INDESIT company

Model type:
MTB241

Commercial code:
F028992

Notices

0521123: SEALS FOR DOORS FOAMED AS ONE PIECE

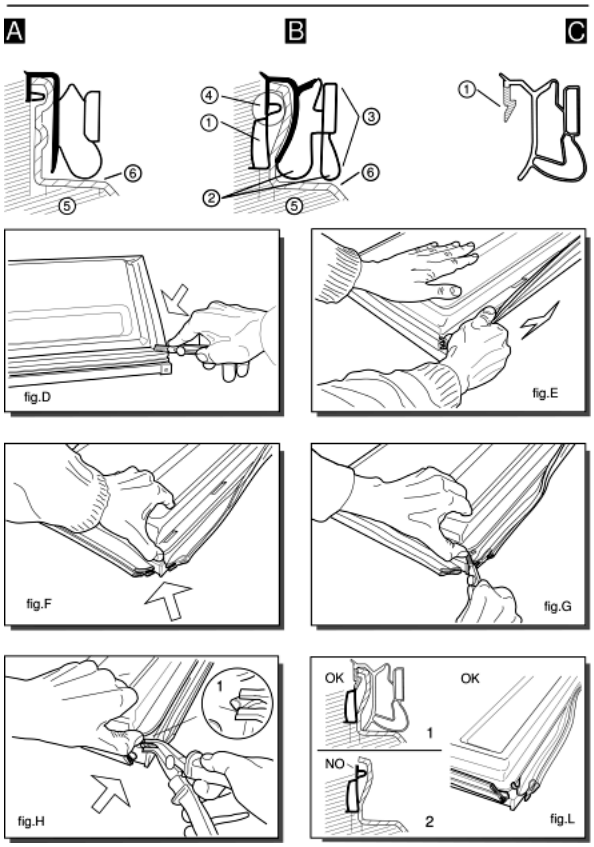
Various types of gaskets with different profile, as shown in figures (A) and (B), are used to fix the door (fig. A-5; B-5) and the inner door (fig. A-6; B-6) on the block foamed doors of combined freezers and refrigerators.
---Ilpea profile 245; 179; 412 (fig.A)
---Ilpea profile 287 (fig.B)
When replacing gaskets with profiles 245; 179; 412 these are fixed with screws (2 per corner) to the door.
Gaskets with profile 287 can not be used as spare parts but are designed to house the Ilpea type 900 gaskets (see figure C).
When replacing the gasket (287), once it is removed you will find a pocket (fig. B-1) between the door and inner door.
The rigid tooth (fig.C-1) of the gasket (900) is inserted inside between the pocket and the inner door, doing away with the need for screws.
Gasket with profile 287 is easy to identify since it has an exterior double edge (fig.B-2) which acts as a cushion when the door is closed.

To replace this gasket, follow these steps:
---Dismount the door and cut the four corners of the gasket along the joint (fig.D);
---lift the gasket and pull it carefully along its full length without tearing it (fig.E).
The purpose here is to detach the inner door slightly from the foam along the exterior edge for a depth equal to that of the gasket (fig.B-3);
---lift the corner of the inner door slightly, prising it up with your thumb (fig.F). Do not use a tool which might break the inner door;
---continue cutting the gasket inside the inner door for about 6 mm (fig.G);
---push in the tip of the pliers (type USAG N131) and pull outwards until you see the top edge of the pocket (fig. B-4) which is empty (fig.H-1);
---if you carry out this operation correctly (fig.L) you will be able to pull off the top edge of the pocket for the full length of the door.
If the gasket tears before the top edge (fig. L-2) you should repeat this operation from the other corner of the door.

---once the gasket (287), has been removed the space above the pocket (fig. L-1) can house the rigid tooth (fig. C-1) of the gasket 900.
When you fit this gasket ensure that it lies flush against the edge for the full length of the door.
If the rigid tooth is difficult to fit, eliminate any residues of foam between the door and the inner door in the gasket area.
fig.5131549A

N1025158FIG1

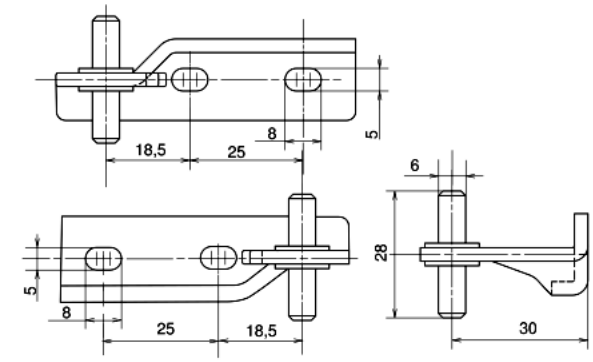
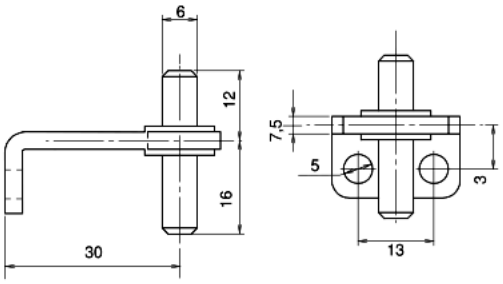
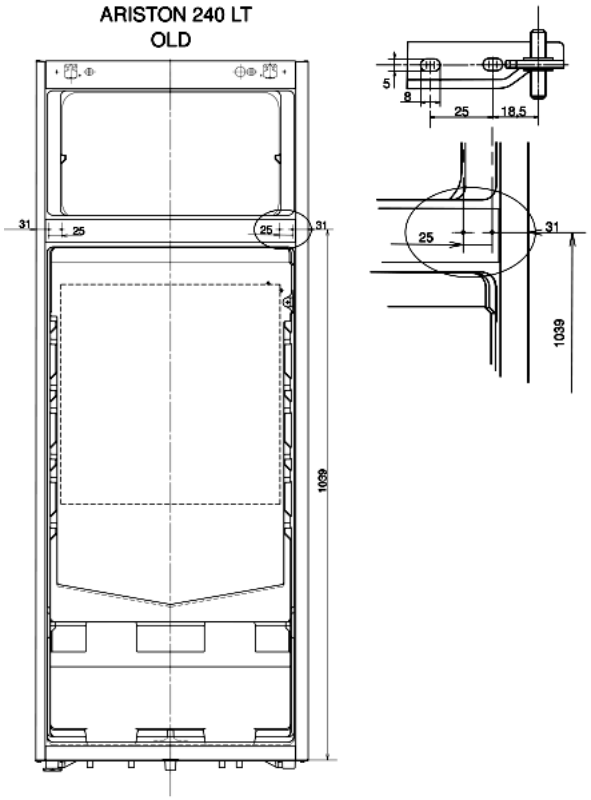
n1025158: New central hinge for Ariston-55 2-door 240 litre refrigerators (Carinaro).

From serial no. 60123.0001, the Carinaro factory has modified the body of 240 litre refrigerators by introducing a new central hinge (see figure N1025058 Fig.1) attached to the side panel.
This hinge is still reversible but cannot be fitted on premodification models where the hinge was attached to the central trim of the refrigerator body (see Figure N1025058fig2).
When changing the door opening from right to left, the new hinge does not need to be inverted like the previous one, just moved to the left side.
To secure it, a hole must be made on the left side of the refrigerator body (see figure N1025058fig3).

Parts affected

141794 - POLAR WHITE CENTRAL HINGE (CARINARO)
142756 - POLAR WHITE CENTRAL HINGE (MANISA)
142756 - CHROME-PLATED CENTRAL HINGE

Parts replaced

053838 - CHROME-PLATED CENTRAL HINGE
053478 - WHITE CENTRAL HINGE
114624 - POLAR WHITE CENTRAL HINGE

OLD 053838 - 053478 - 114624

NEW 141794 - 142760 - 142756
